EL MONTE UNION HIGH SCHOOL DISTRICT

April 14, 2023

TO : All Bidders
FROM : El Monte Union High School District
BID # : 2022-23(B8)
PROJECT : Mountain View HS Modernization Project
SUBJECT : Addendum No. 2

1. LPA Architects Addendum No. A issued April 14, 2023 attached.

DEMOLITION
PLAN

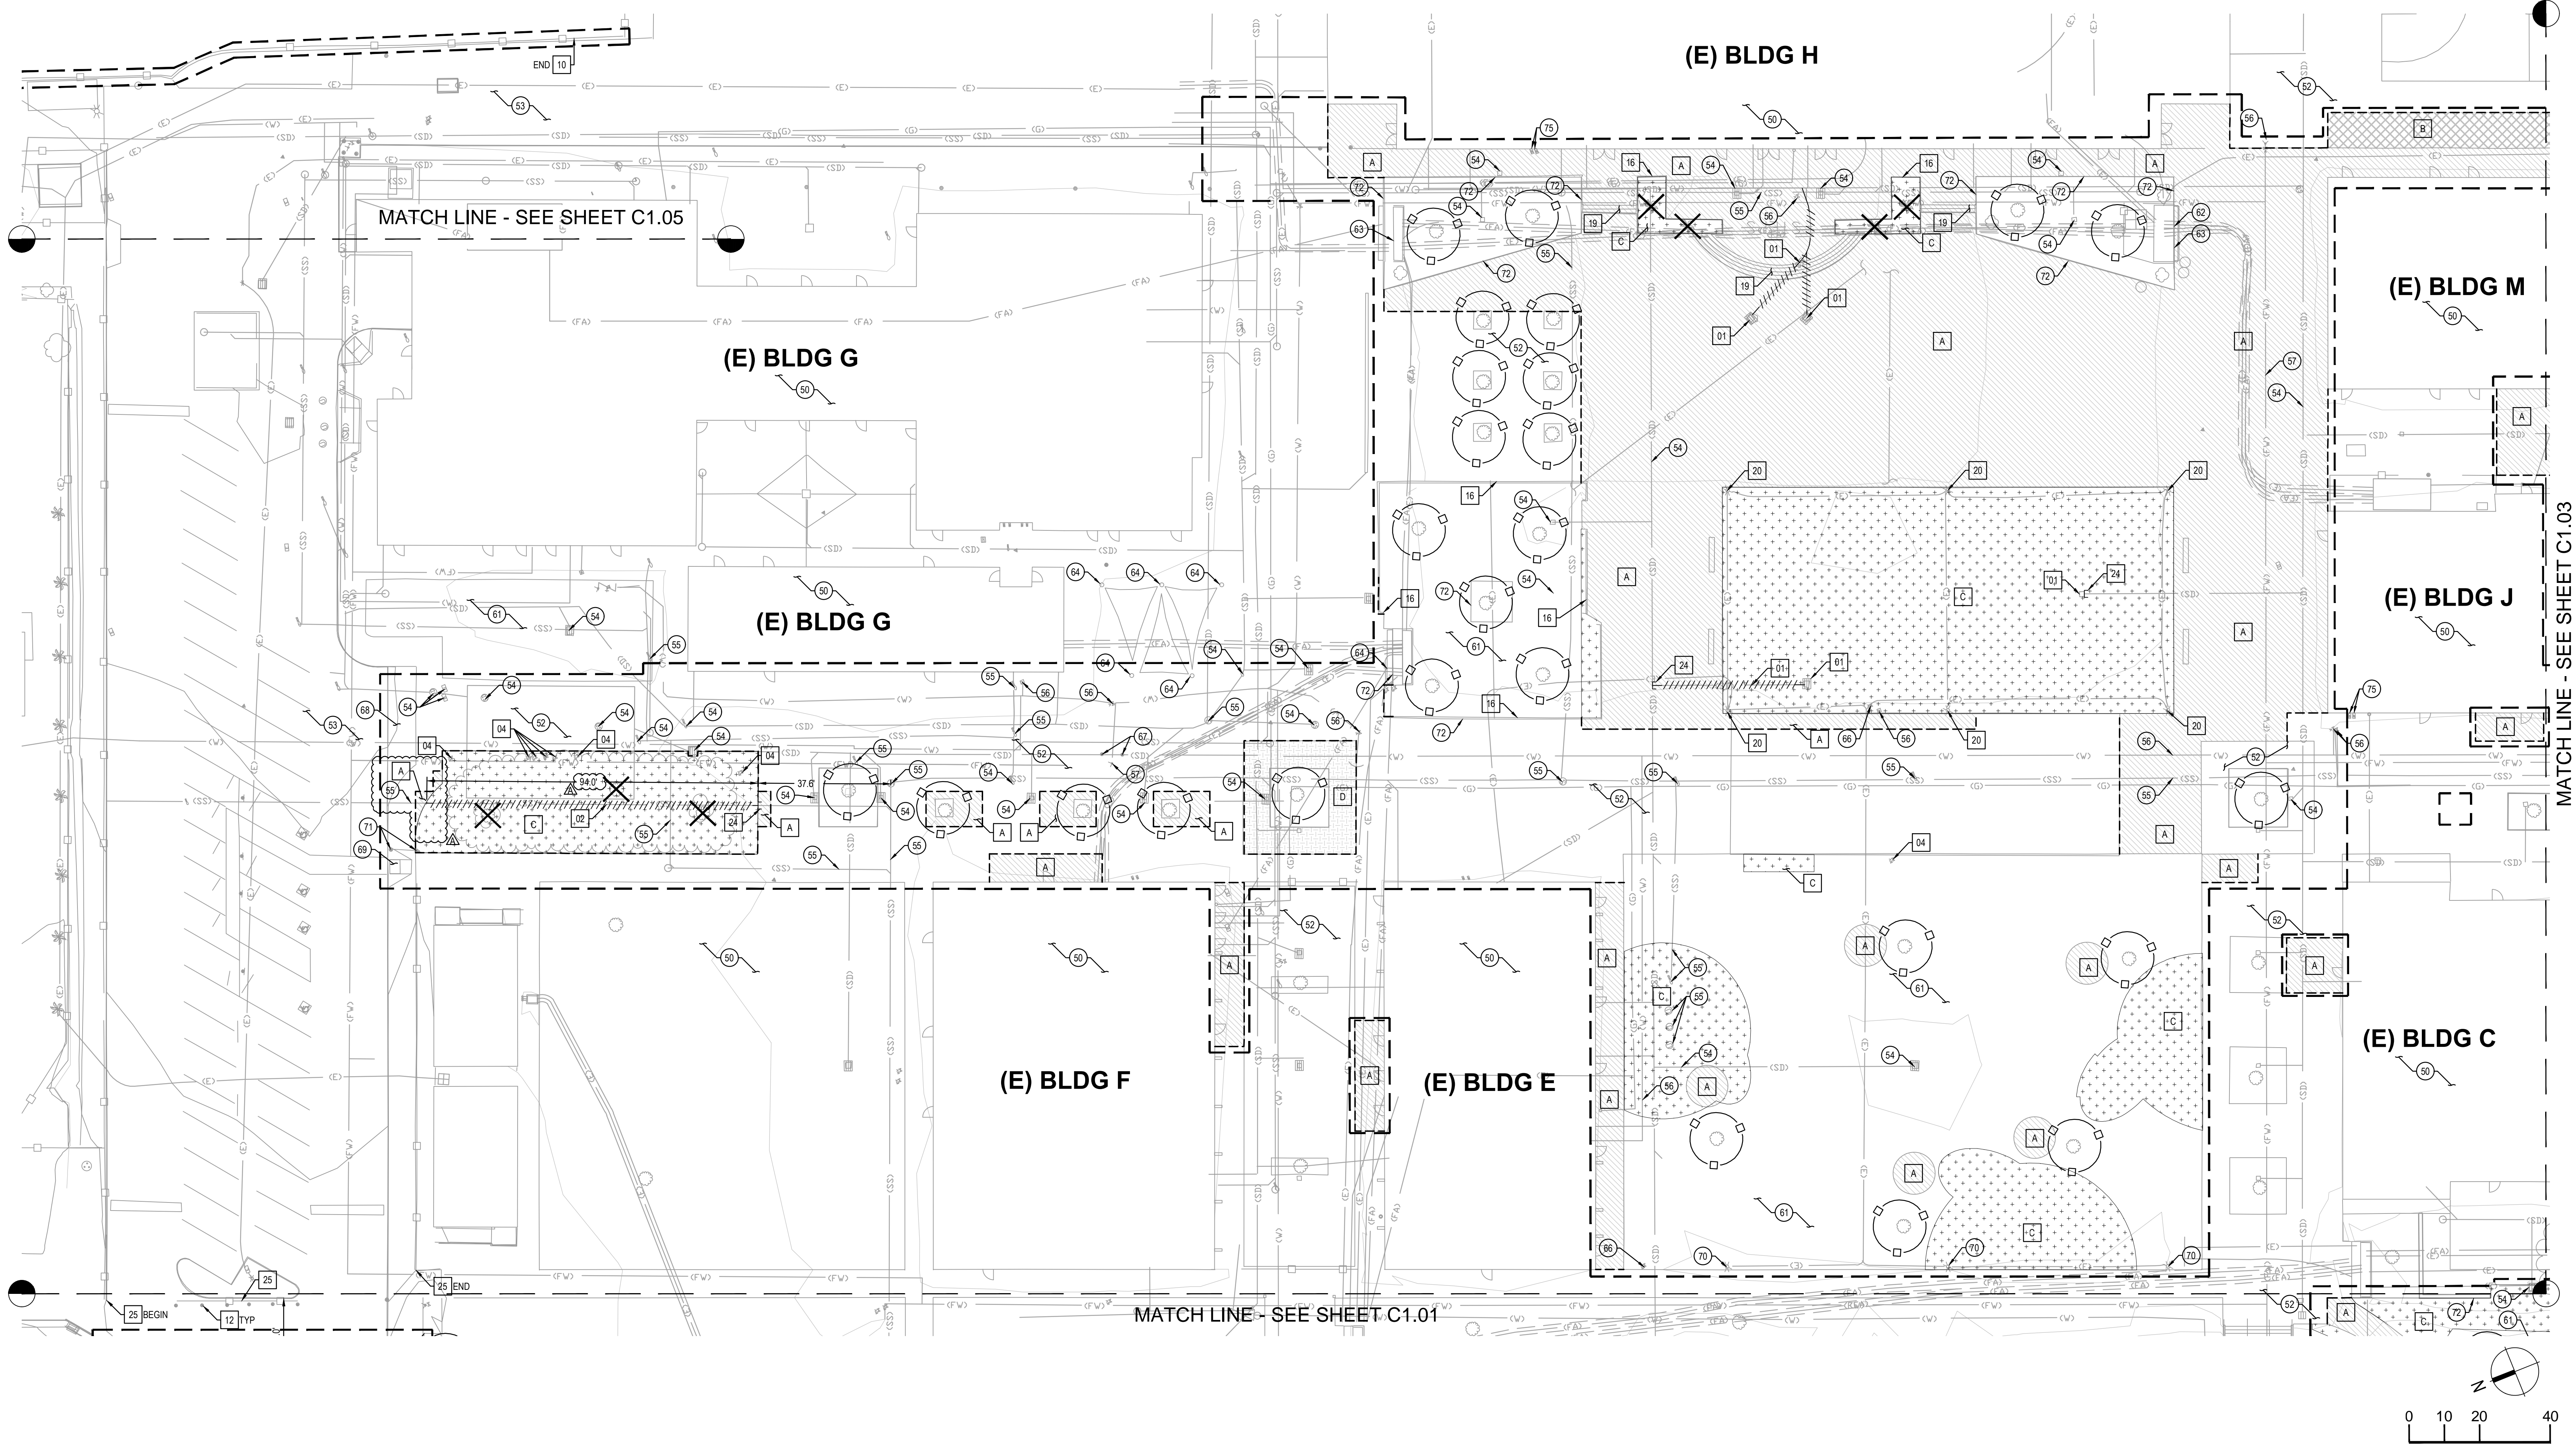
| Item No. 5 | Sheet C1.03 – Demolition Plan

GRADING
PLAN

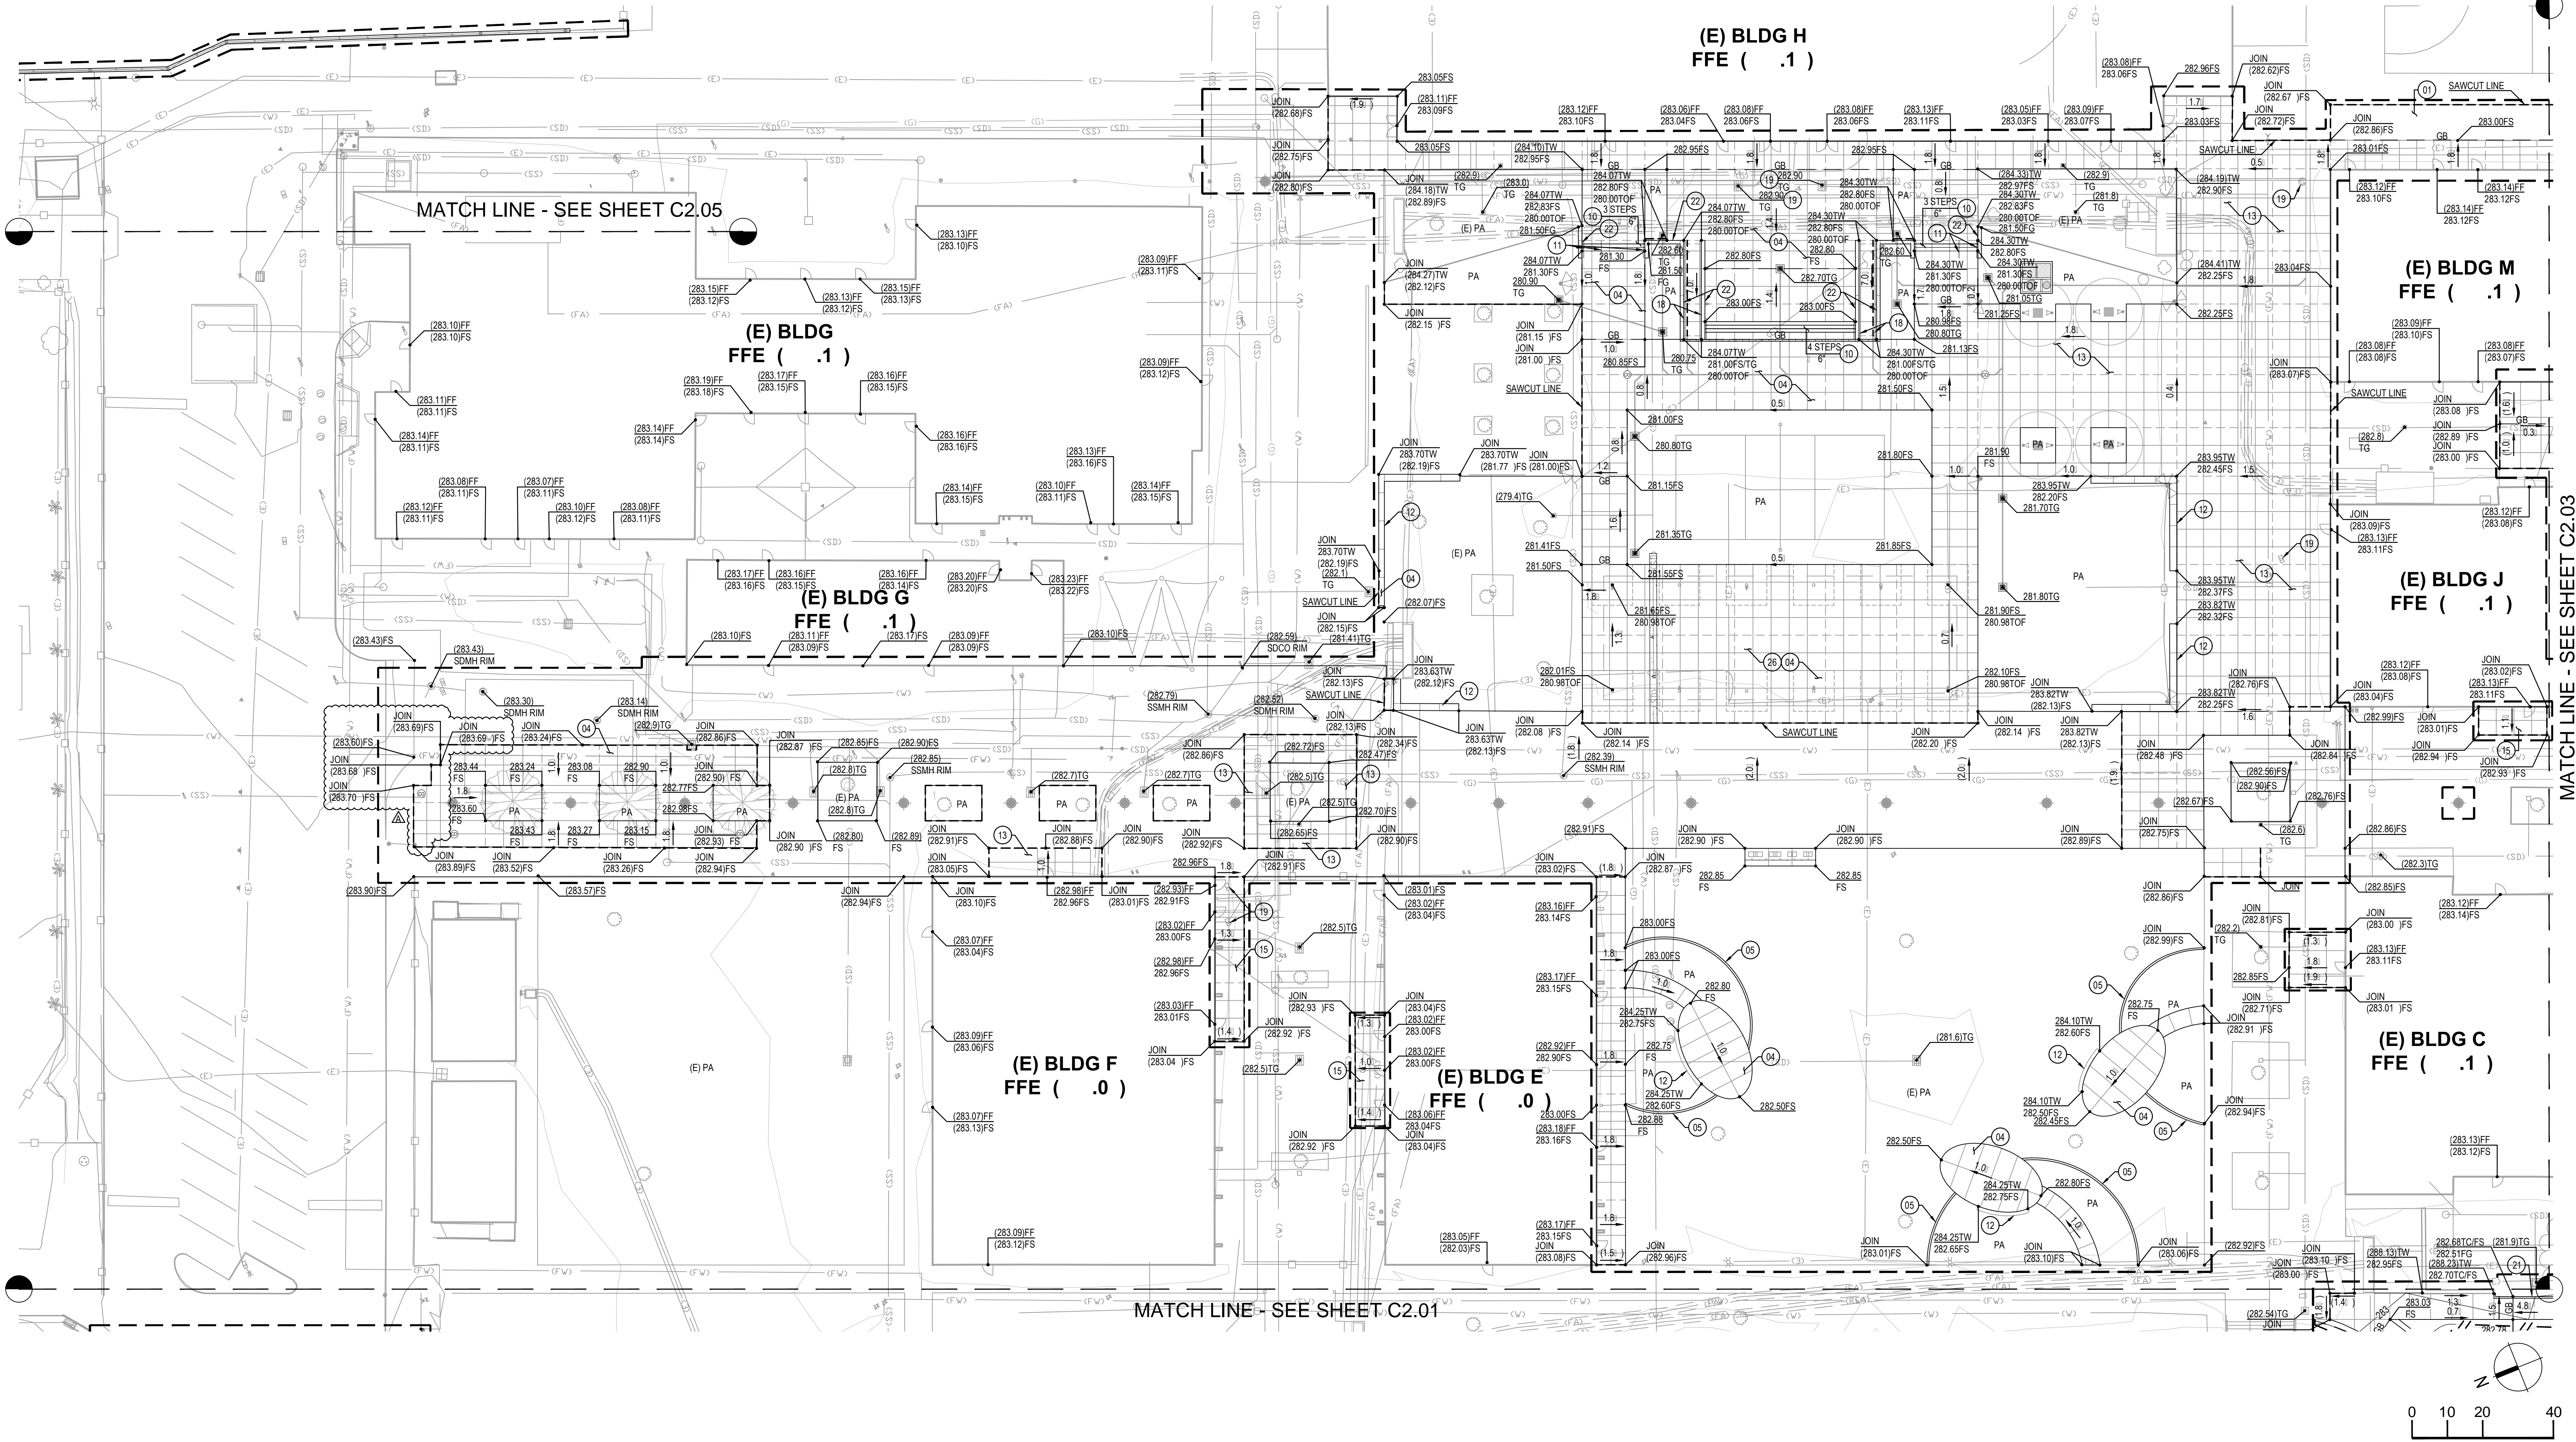
| Item No. 7 | Sheet C2.03 – Grading Plan

PAVING AND
STRIPING
PLAN

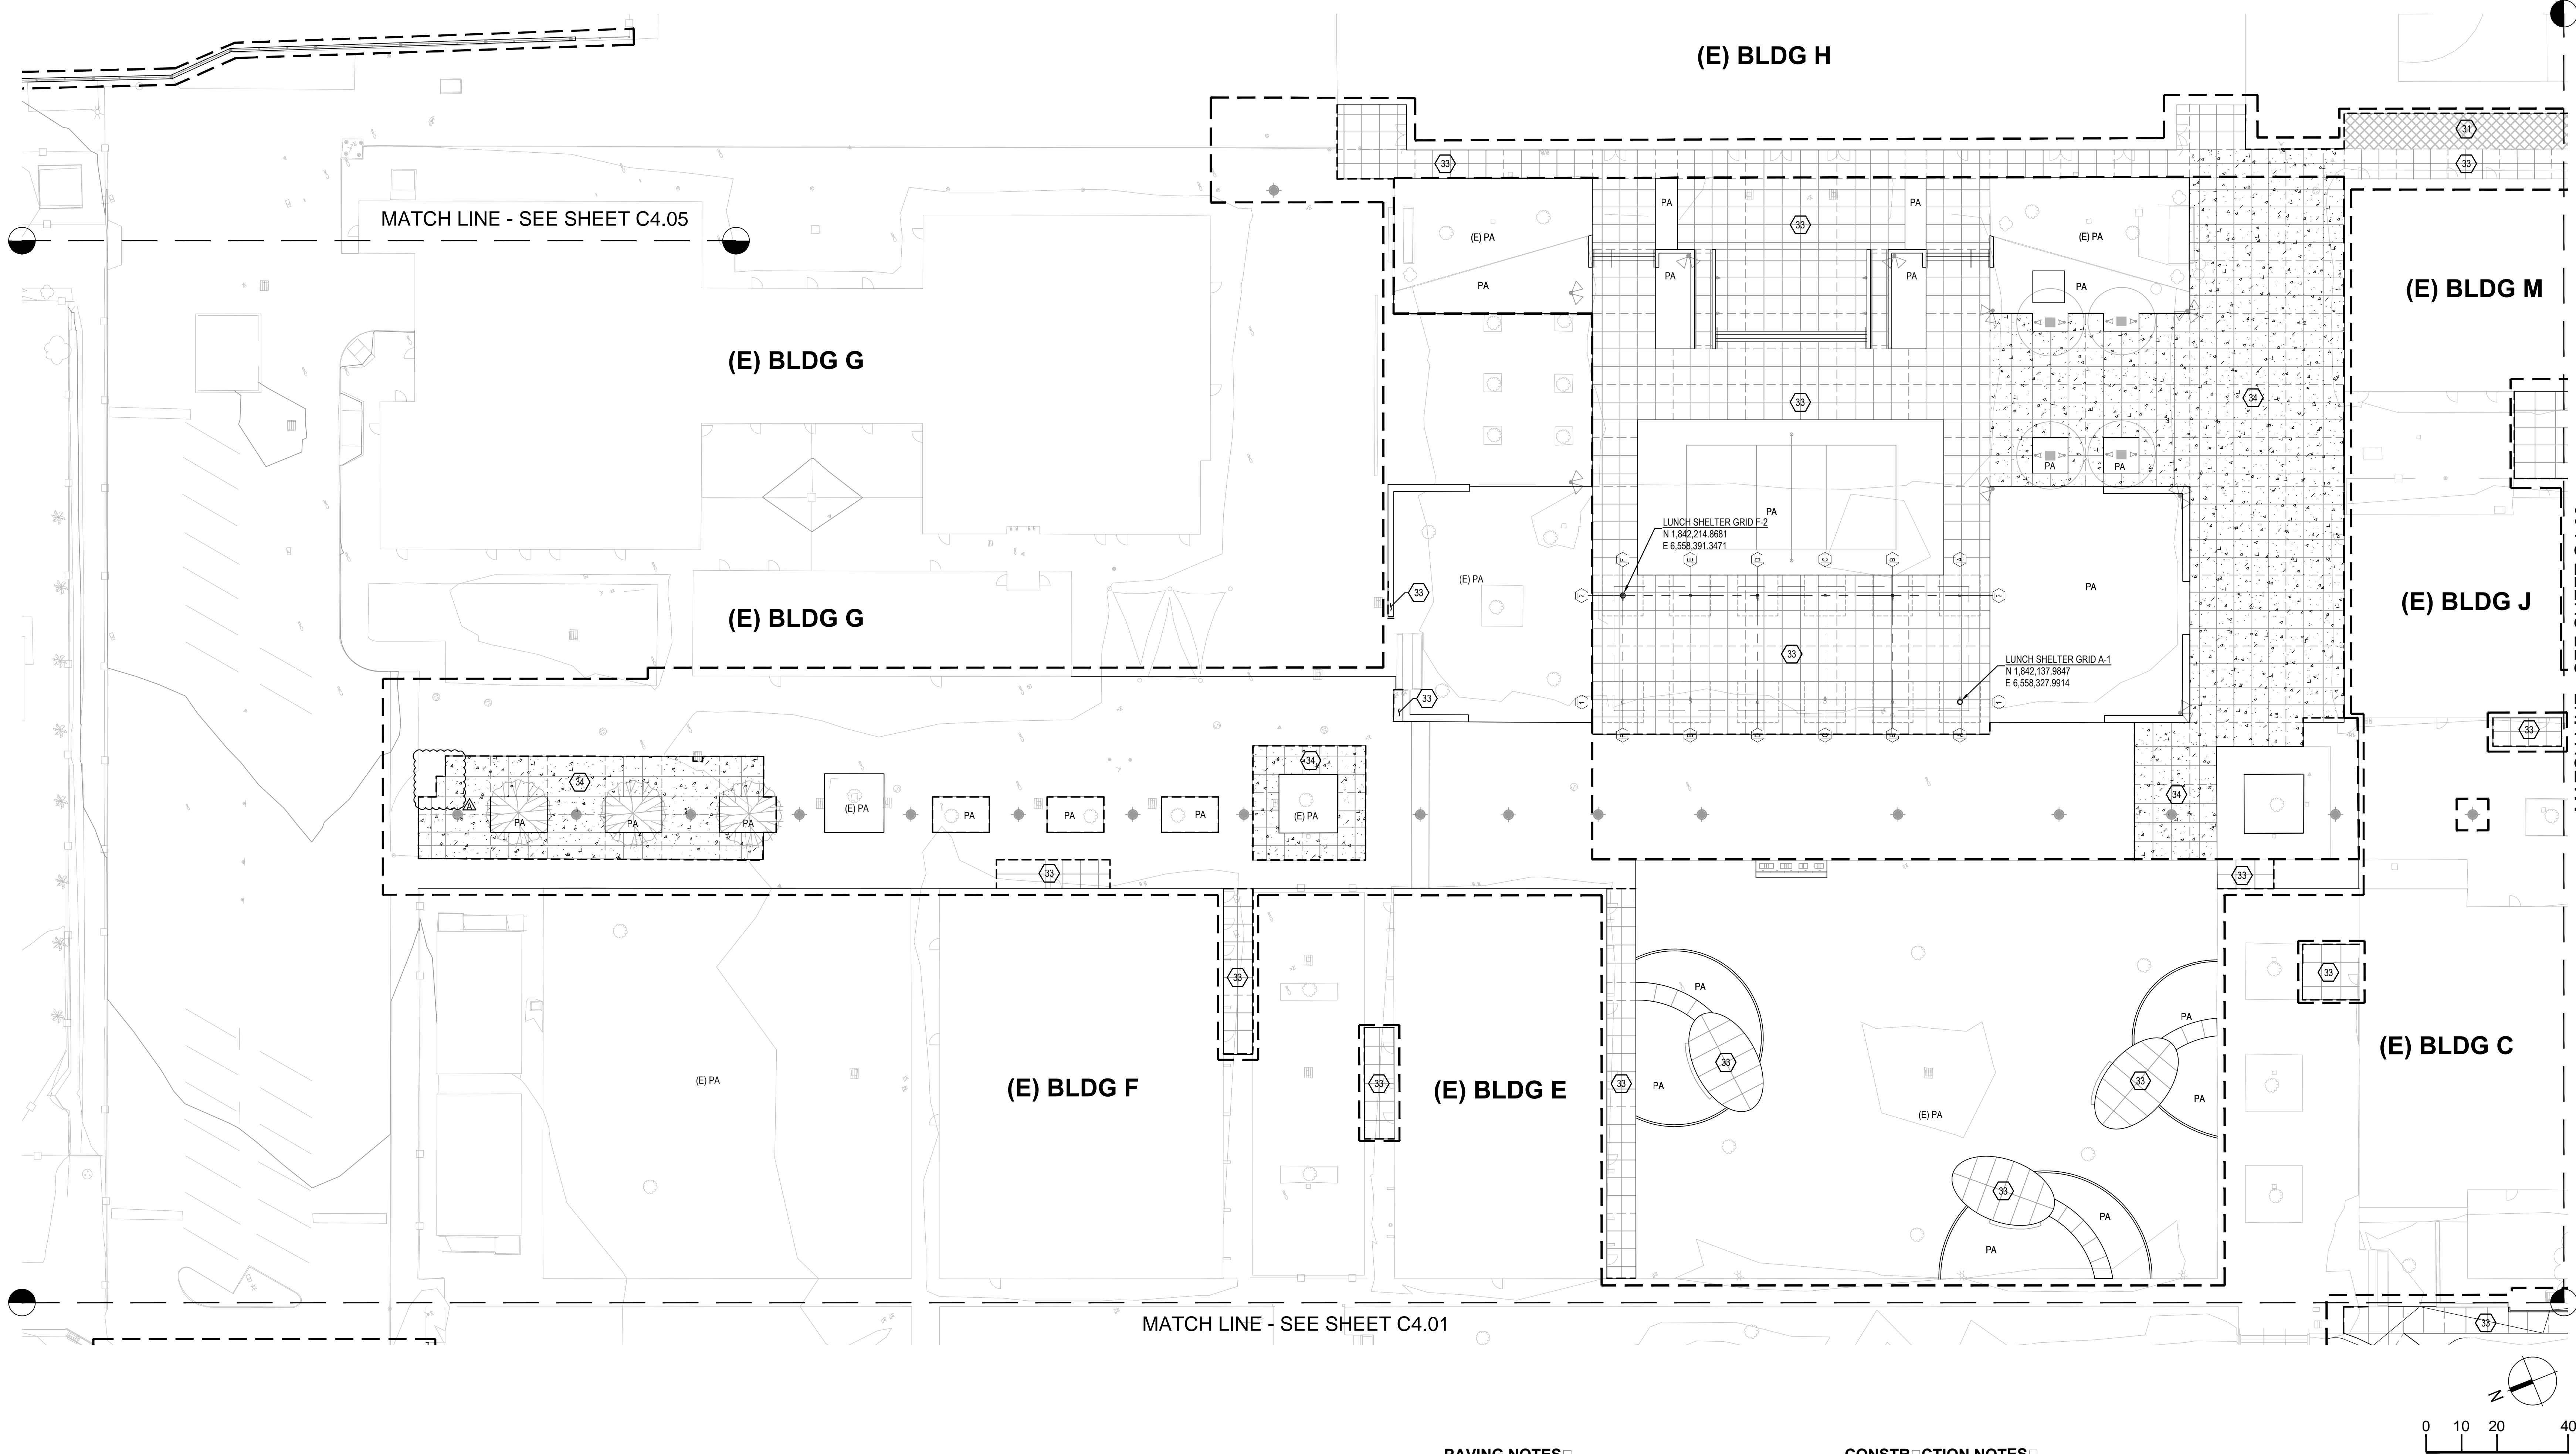
| Item No. 10 | Sheet C4.03 – Paving Plan

Added sawcut line and callout for concrete trench repair |
